SUBJECT: PRESSURE-TEMPERATURE LIMITS FOR THE REACTOR VESSEL
(TAC NO. 73600)

RE: PEACH BOTTOM ATOMIC POWER STATION, UNIT NO. 2

AMENDMENT TO FACILITY OPERATING LICENSE

Amendment No. 153
License No. DPR-44

Figure 3.6.1 Peach Bottom 2 Minimum Temperature for Pressure Tests Such as Required by Section XI

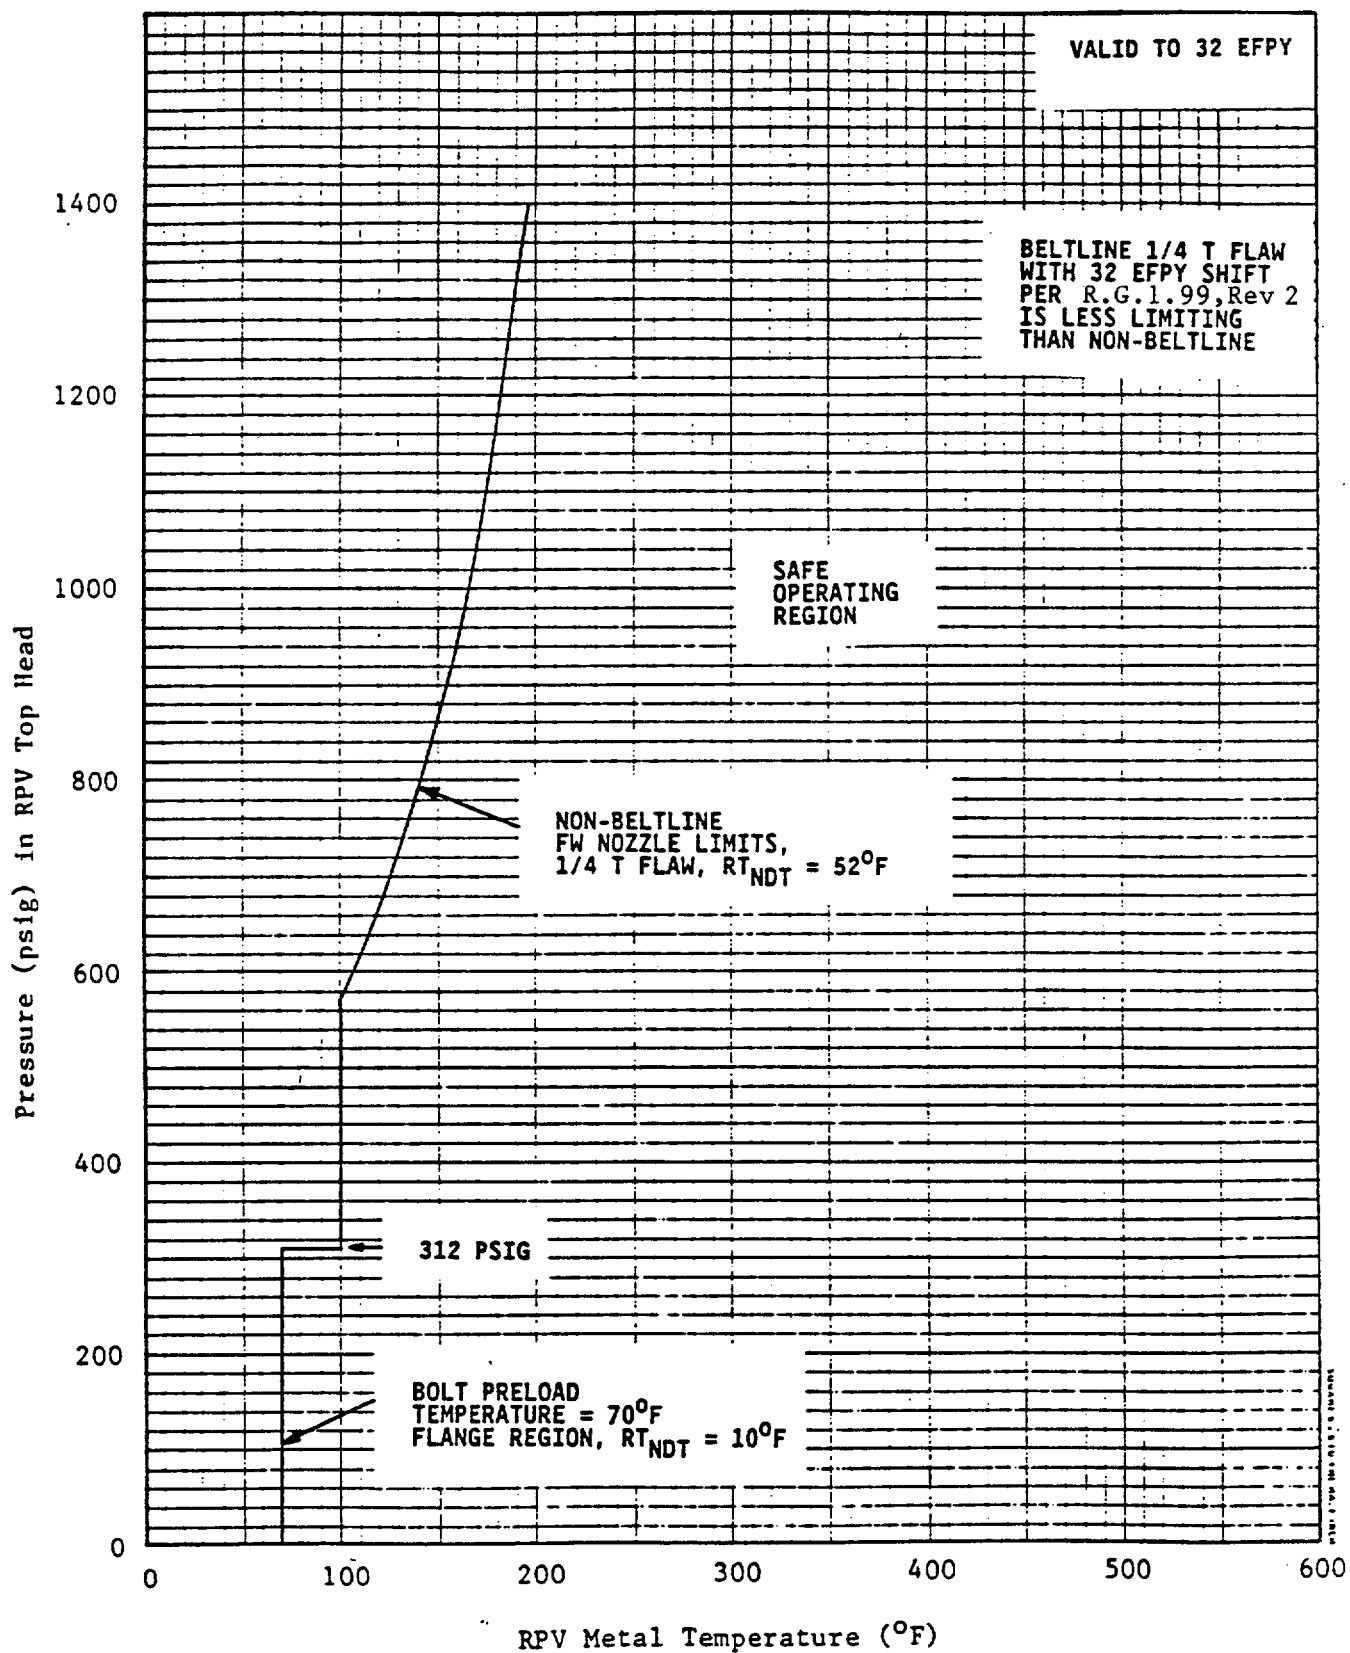
1. The average rate of reactor coolant temperature change during normal heatup or cool-down shall not exceed 100° F increase (or decrease) in any one-hour period.
2. The reactor vessel shall not be pressurized for inservice hydrostatic testing above the pressure allowable for a given temperature by Figure 3.6.1.

Selected surveillance specimens shall be removed* and tested to experimentally verify or adjust the calculated values of integrated neutron flux and irradiation embrittlement that are used to determine the RT^{NDT} for Figures 3.6.1, 3.6.2 and 3.6.3, and the figures shall be updated based on the results.

The flux wire test results provide the flux at one location in the vessel. The flux distribution can be determined analytically from the core physics data. The ratio of the flux at the peak vessel location to that at the flux wire location, known as the lead factor, was calculated to relate the flux wire test results to the maximum value for the vessel. In developing Figures 3.6.1, 3.6.2 and 3.6.3, the shift predicted by Regulatory Guide 1.99, Revision 2 methods for 32 EFPY of fluence was taken into account. However, in comparing the beltline operating limits (with 32 EFPY shift) to the feedwater nozzle limits, it was determined that the feedwater nozzle was more limiting. Since the feedwater nozzles do not experience significant changes in fracture toughness due to irradiation, the pressure-temperature limits in Figures 3.6.1, 3.6.2 and 3.6.3 apply, without any RT_{NDT} shifting, through 32 EFPY of operation.

For the limiting beltline material, C2873-1, the staff calculated the ART to be 51°F at $1/4T$ (T = reactor vessel beltline thickness) for 32 EFPY. The staff calculated the ART by the method described in Section 1 of RG 1.99, Rev. 2 because only one surveillance capsule had been withdrawn from the Peach Bottom 2 reactor vessel. The licensee calculated the same 51°F for the ART. Substituting the ART of 51°F into equations in SRP 5.3.2, the staff verified that the proposed P/T limits for heatup, cooldown, and hydrotest meet the beltline material requirements in Appendix G of 10 CFR Part 50.

The staff concludes that the proposed P/T limits for the reactor coolant system for heatup, cooldown, leak test, and criticality are valid through 32 EFPY because the limits conform to the requirements of Appendices G and H of 10 CFR Part 50. The licensee's submittal also satisfies Generic Letter 88-11 because the licensee used the method in RG 1.99, Rev. 2, to calculate the ART. Hence, the proposed P/T limits may be incorporated into the Peach Bottom 2 Technical Specifications.

Figure 3.6.2 Peach Bottom 2 Minimum Temperature for Mechanical Heatup or Cooldown Following Nuclear Shutdown

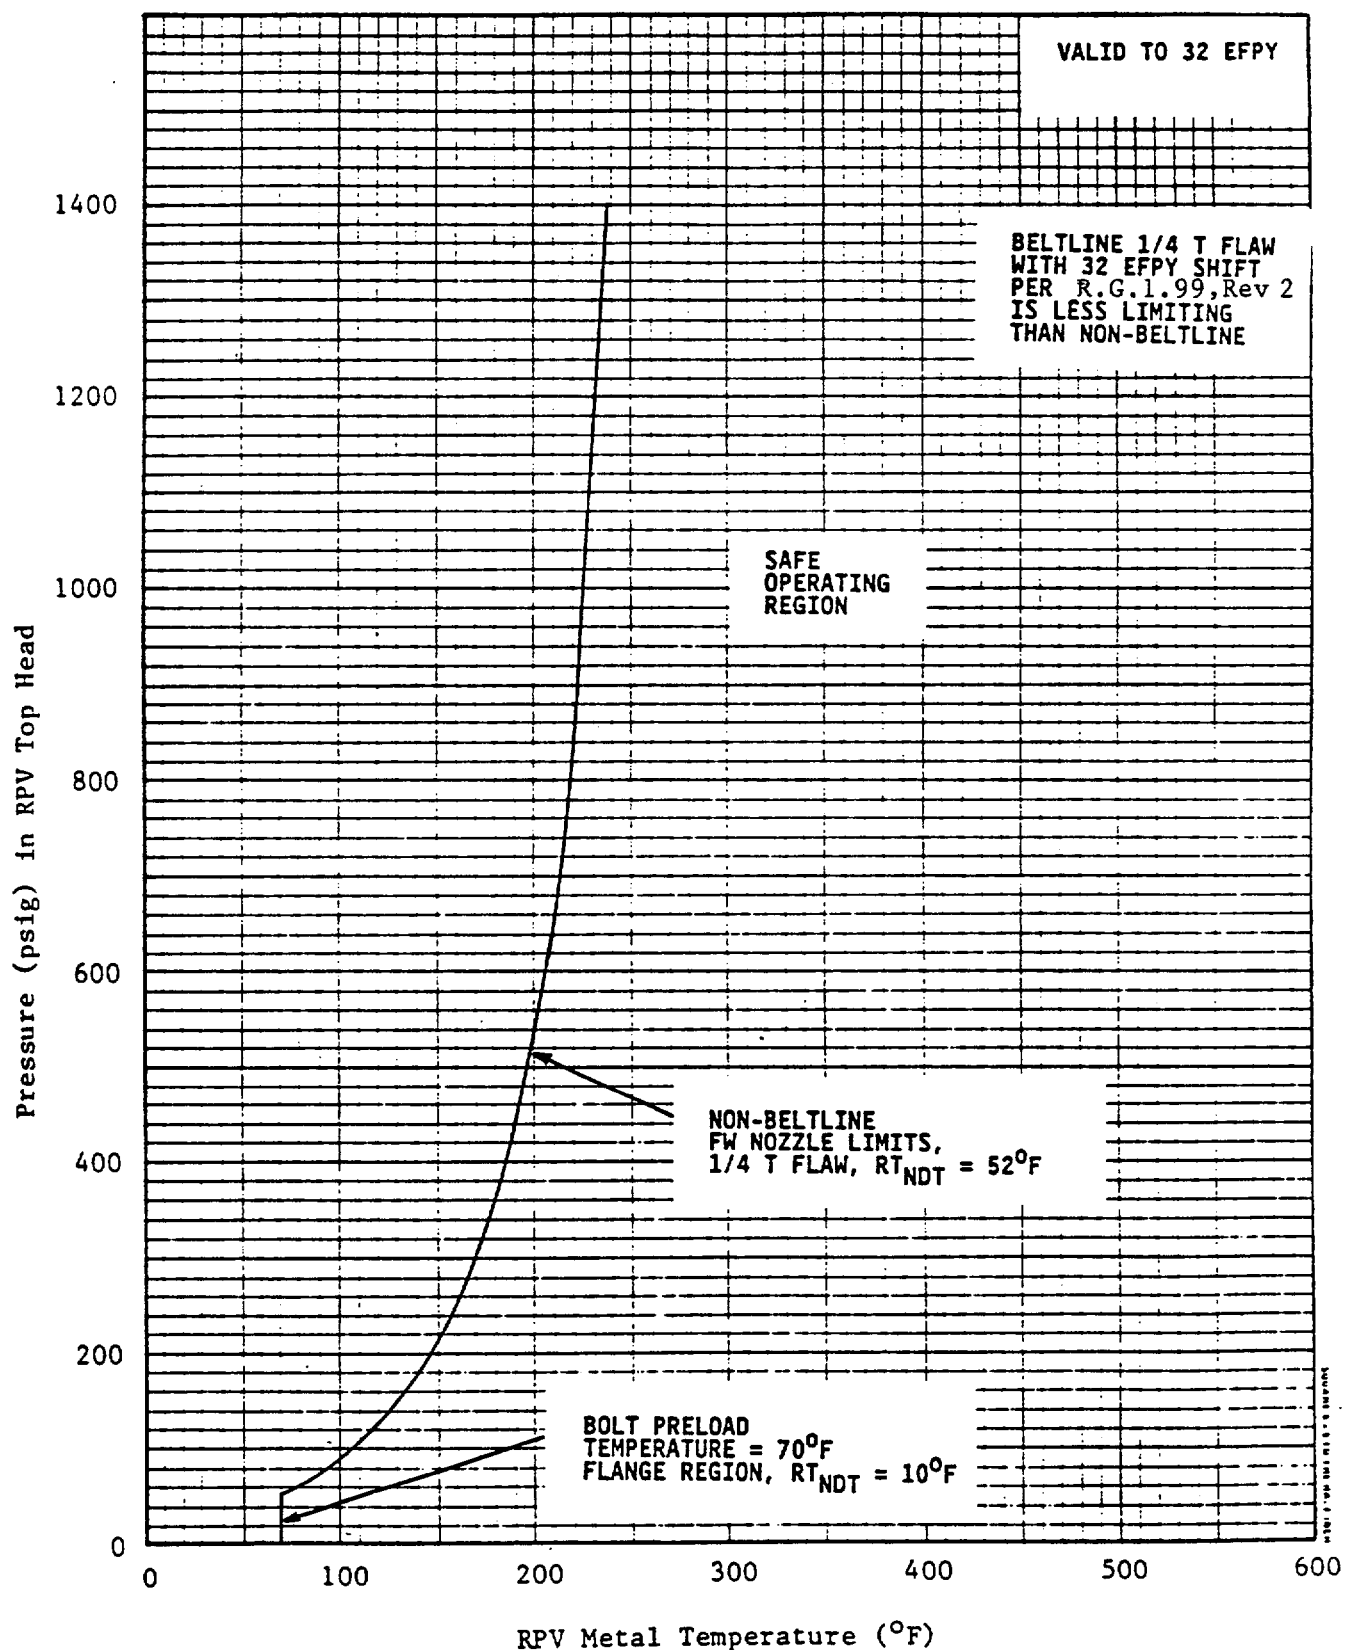
The reactor vessel shall not be pressurized during heatup by non-nuclear means, during cooldown following nuclear shut down or during low level physics tests above the pressure allowable by Figure 3.6.2, based on the temperatures recorded under 4.6.A.

Figure 3.6.3 Peach Bottom 2 Minimum Temperature for Core Operation (Criticality)

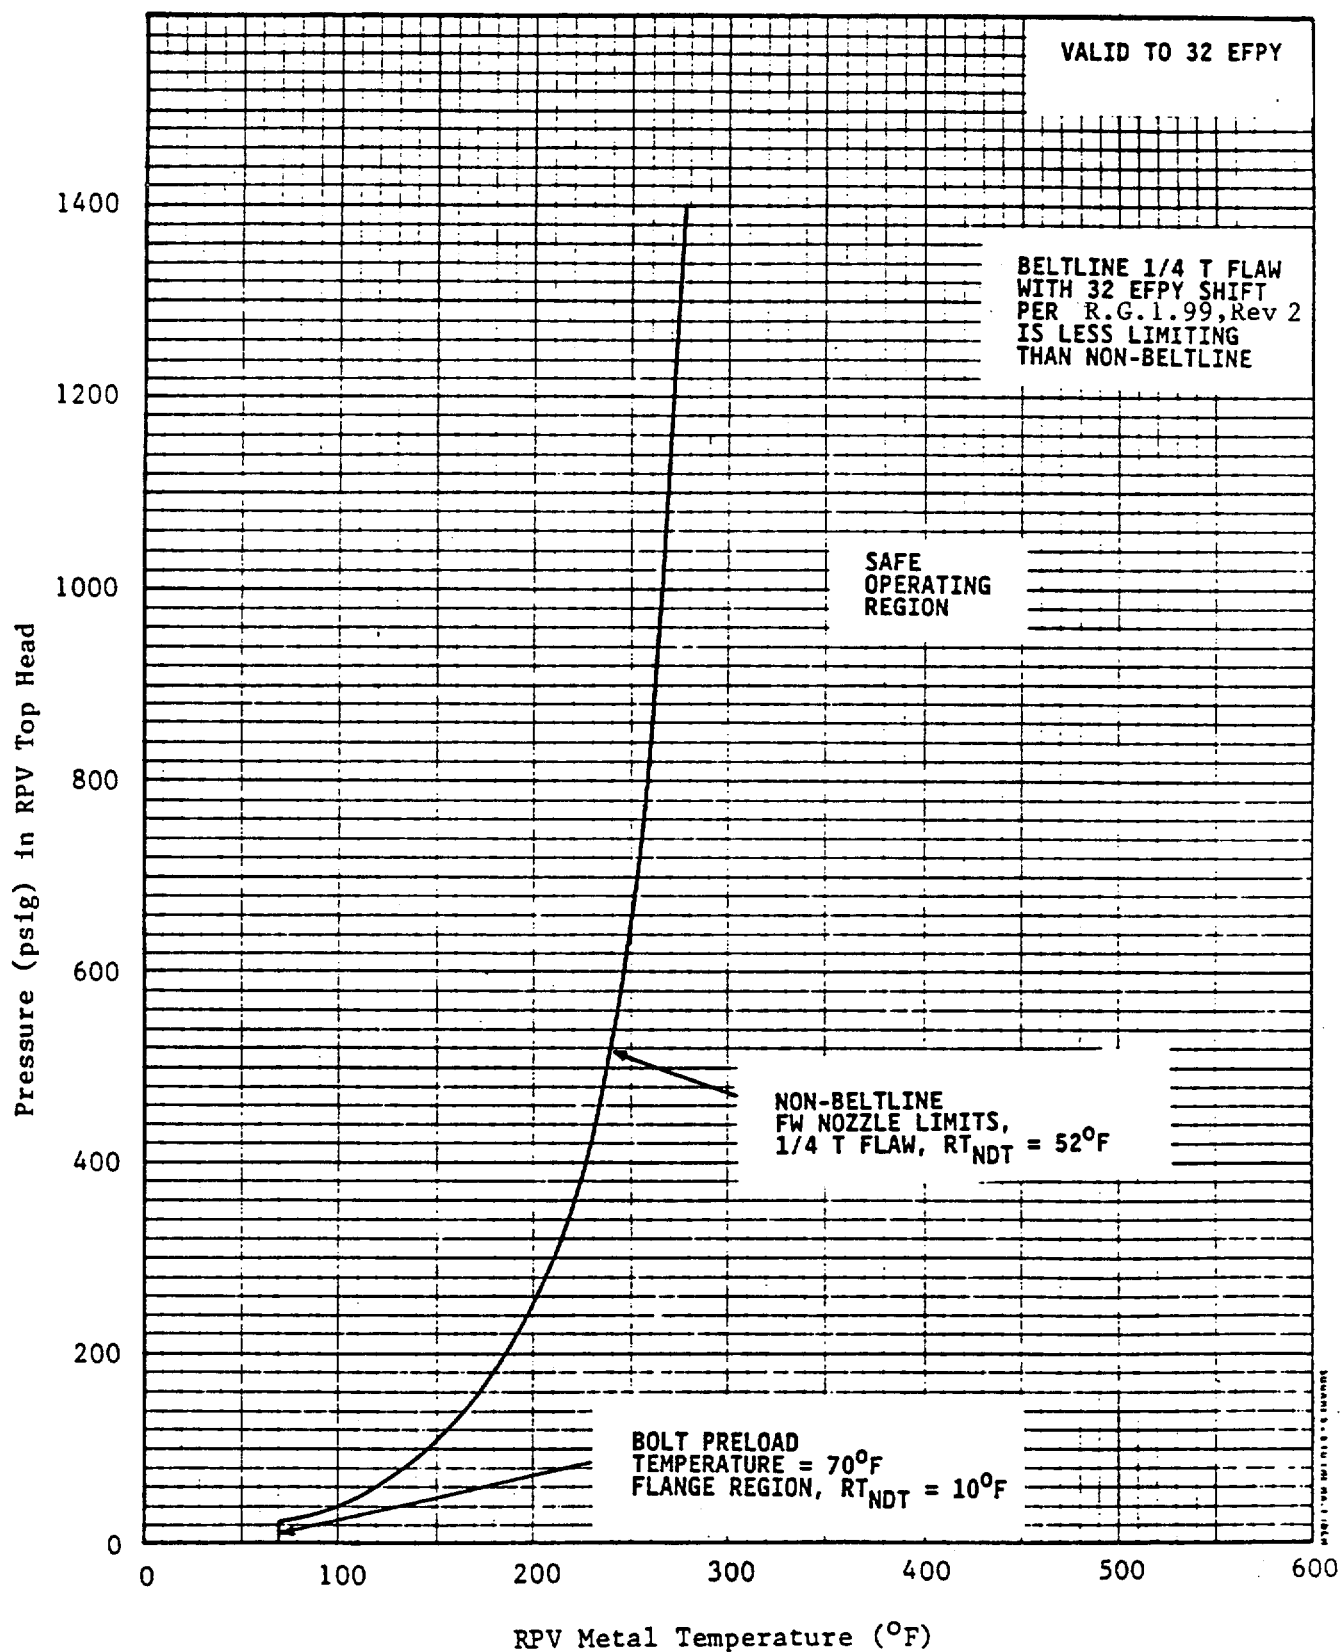
The reactor vessel shall not be pressurized during operation with a critical core above the pressure allowable by Figure 3.6.3, based on the temperatures recorded under 4.6.A.

Operating limits on the reactor pressure and temperature were developed after consideration of Section III of the ASME Boiler and Pressure Vessel Code and Appendix G to 10 CFR Part 50. These considerations involved the reactor vessel beltline and certain areas of discontinuity (e.g. feedwater nozzles and vessel head flange). These operating limits (Figures 3.6.1, 3.6.2 and 3.6.3) assure that a postulated surface flaw can be safely accommodated. Figure 3.6.3 includes an additional 40° F margin required by 10 CFR 50 Appendix G.
